INSTALLATION INSTRUCTIONS

MSD Crab Cap, PN 8541
For Distributors, PN 8486, PN 8489

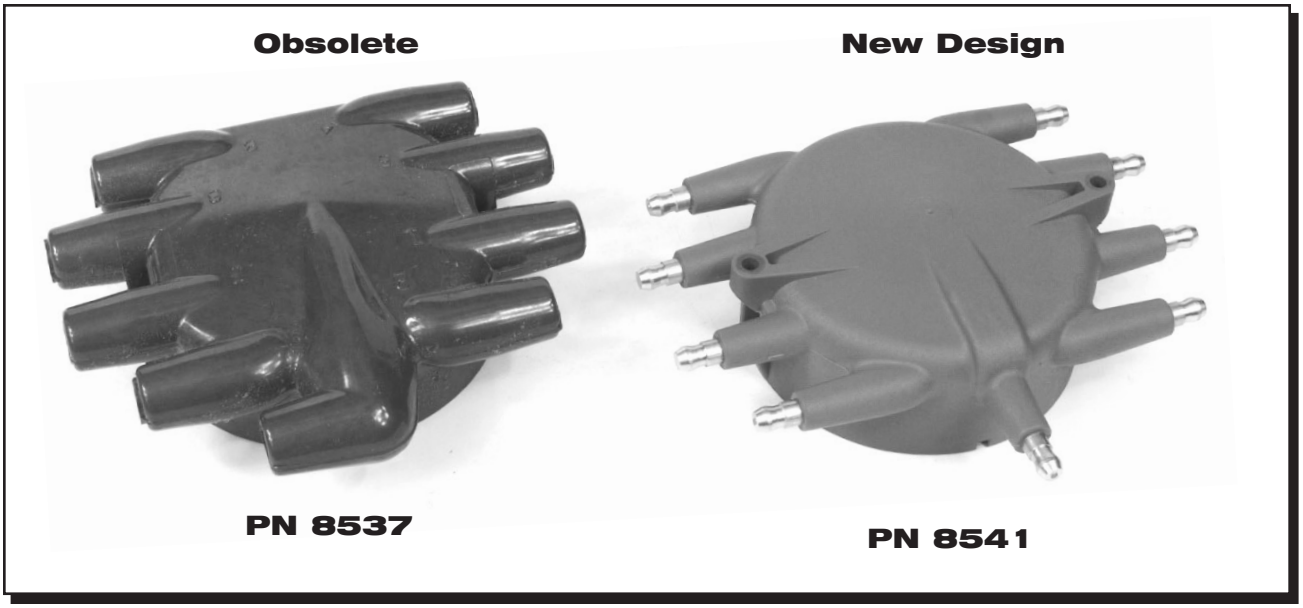
This Cap is an updated replacement for the PN 8537 Cap which is now obsolete. The new design is injection molded from Dupont Rynite material which is stronger physically and holds higher dielectric strength.

This Cap also incorporates spark plug style terminals for an improved connection to the plug wire terminals. This change necessitates different terminals and boots for the spark plug wires. A set of nine short 90° boots and terminals is available as PN 8848.

This Cap has the hold-down retaining bosses molded in and simply screws down to the distributor base using the same socket head cap screws. The original rotor, PN 8567, and rotor base, PN 8568, are still used.
